Date	Group	No.	Release	Page
2.2014	396	001	03	1(4)

Auxiliary A/C Inverter Case Ground VN Models

SP396-001, Auxiliary A/C Inverter Case Ground

(February 2014)

W3086000

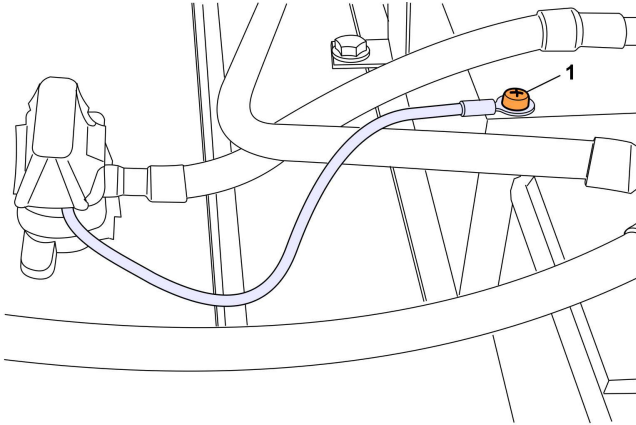
- 1 Secure the vehicle for service by parking it on a flat level surface, applying the parking brake, chocking the rear wheels, and placing the transmission in neutral.
- 2 Remove battery cover.
- 3 Disconnect all cables from the negative (ground) battery terminal to prevent personal injury from electrical shock and prevent damage to electrical components.
- 4 Remove the redundant (green) wire **(2)** from the inverter case and battery box.

Note: Discard the wire after removal.

Note: Discard the ground screw on battery box.

W3086001

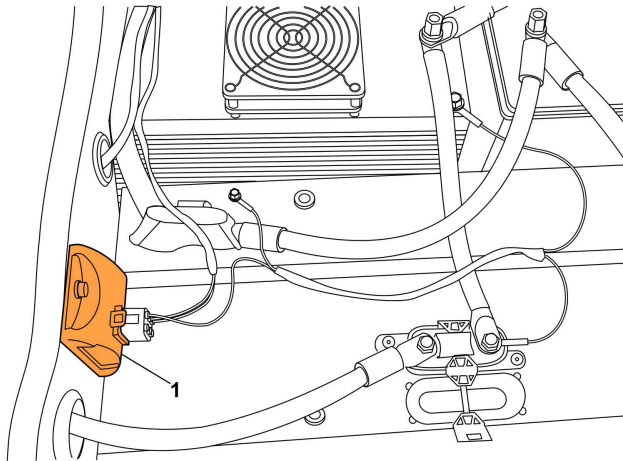
- 5 Secure the inverters' (corner ground) screw **(1)**. Tighten to 4 - 6 Nm (36 - 54 in lbs).

W3087316

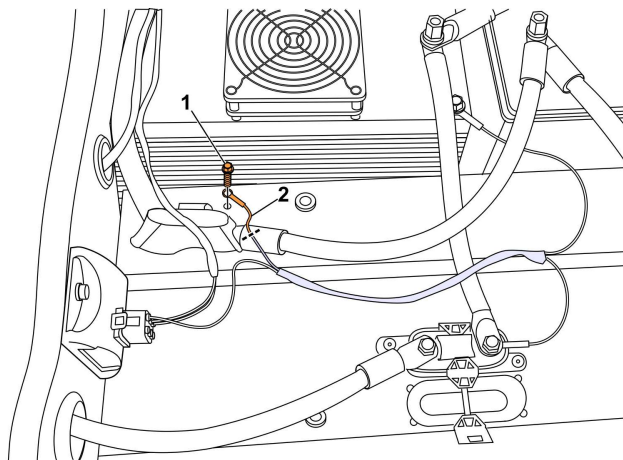
- 6 If unit is equipped with a Low Voltage Disconnect (1), the redundant wire will be grey in color going to battery box floor.

- 7 Remove the screw (1) and cut the ring terminal from the gray wire (2).

Note: Do not allow the wire to touch the battery box.

W3087631

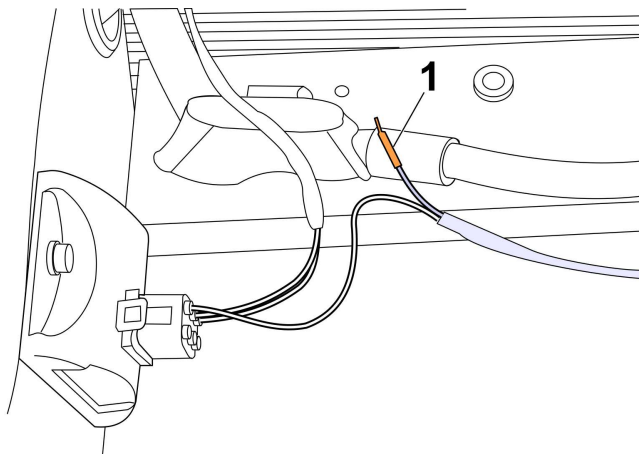
- 8 Apply heat shrink tubing to the end of wire and secure.
